Modification Bulletin

Model: Model K- P3	3		Date	e: 2-Oct-03		No.: MG091001	
Modified Article: Parts catalog correction			Prepared by: T.Shintani				
From: 1st Technical Support Sec. Service Support Dept.							
Reason for Modification:	 Parts catalog correction To facilitate assembly Part standardization 	 Vendor change To improve reliability Other 		☐ To n (neet standards)		
Modification Schedule:	From first mass production.

Modification Bulletin

Model: Model K- P3	3		Date	e: 17-Nov-03		No.: MG091002	
Modified Article: Parts catalog correction				Prepared by: T. Shintani			
From: 1st Technical Support Sec. Service Support Dept.							
Reason for Modification:	 Parts catalog correction To facilitate assembly Part standardization 	Vendor change To improve reliability Other		☐ To n (neet standards)		
Modification Schedule:	From first mass production.

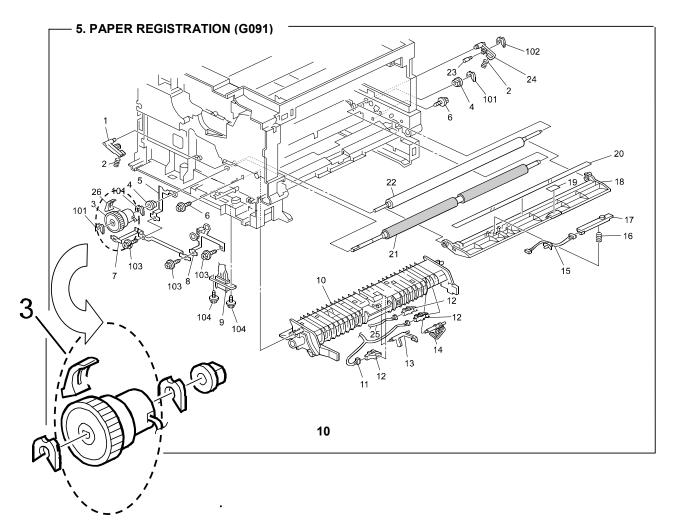
Note: The illustration for the magnetic clutch assembly has been corrected as follows:

Incorrect	Correct	Description	Q'ty	Int	Page	Index	Note
Part Number	Part Number	•			•		
AX200208 ¬		Magnetic Clutch – Z45	1→0	- / -	11	3	*
G0763321		Clutch Sleeve Cover	1→0	- / -	11	26	*
	► G0763205	Magnetic Clutch : Registration : Ass'y	0→1	- / -	11	3	*
11050292 –		Wire Saddle	1→0	- / -	23	110	
l	▶ 08025276	Tapping Screw With Washer – M3×6	0→1	- / -	23	106
